# West Gate Tunnel Project

## EES Inquiry and Advisory Committee (IAC)

Statement of landscape and open space evidence

Stephen Schutt of Hansen Partnership Pty Ltd.

Figure 19: 'Photomontage' view at 'Year 10' as represented in the EES (source: EES Technical Report N).

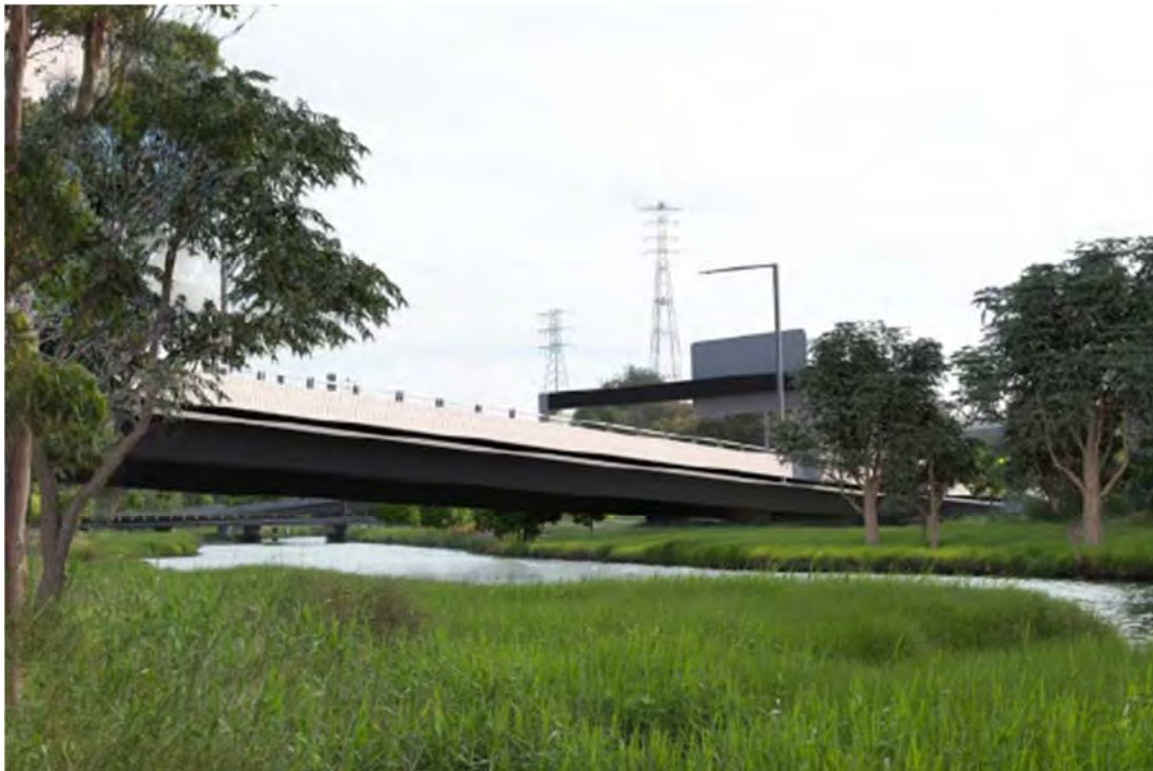
Figure 17: Existing view from Viewpoint 32 as represented in the EES (source: EES Technical Report N).

Figure 18: 'Photomontage' view at 'Year 1' as represented in the EES (source: EES Technical Report N).

Figure 25: Diagrammatic representation of the composition of a panoramic photo to provide a horizontal field of view in the order of 100 degrees.

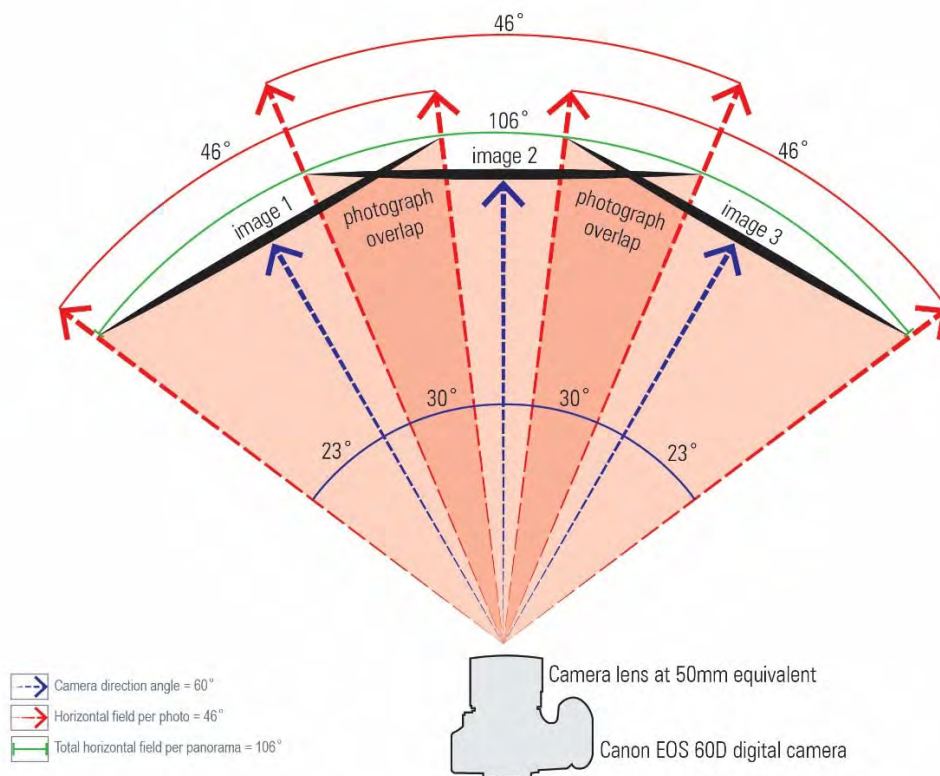
92. However, the 'photomontages' provided within *Technical Report N* as the basis for demonstrating the visual impact of the Project do not represent a horizontal field of view of 100 degrees. It is my estimation that they represent a horizontal field of view of roughly half that extent. To demonstrate, the 'photograph of existing conditions' at Figure 26 below is a reproduction of Figure 102 in EES *Technical Report N*, which – like every other Viewpoint in the EES *Technical Report N* is used as the basis for the preparation of subsequent 'Photomontage' images. By comparison, the panoramic photo in Figure 27 on the following page was taken by me, at a location I have estimated as being within very close proximity to Viewpoint 26 within *Technical Report N*. The panoramic photo prepared by me utilised a camera with a 50mm lens, with a series of photos joined to form a panoramic view which comprises a horizontal field of view in the order of 106 degrees, consistent with the diagram provided in Figure 25 above. When comparing my photo to the photo for Viewpoint 26, the horizontal field of view for the latter is clearly significantly narrower. By representing this – and other – viewpoints with a significantly reduced horizontal field of view to that which a person standing in these locations would actually see, the 'photomontages' provided in *Technical Report N* significantly under-represent the full extent of the proposed structures which would actually be visible. In doing so they significantly under-represent the actual visual impact which will be experienced at those view locations, given that the proposed structures are not individual buildings but rather are continuous linear structures which – by virtue of their horizontality – will have a tendency to occupy significant proportions of any available horizontal field of view.

93. On the basis of the explanation above, it is my opinion that the 'photomontages' provided in *Technical Report N* should not be relied upon as accurate representations of the likely visual impact which will result from the Project.
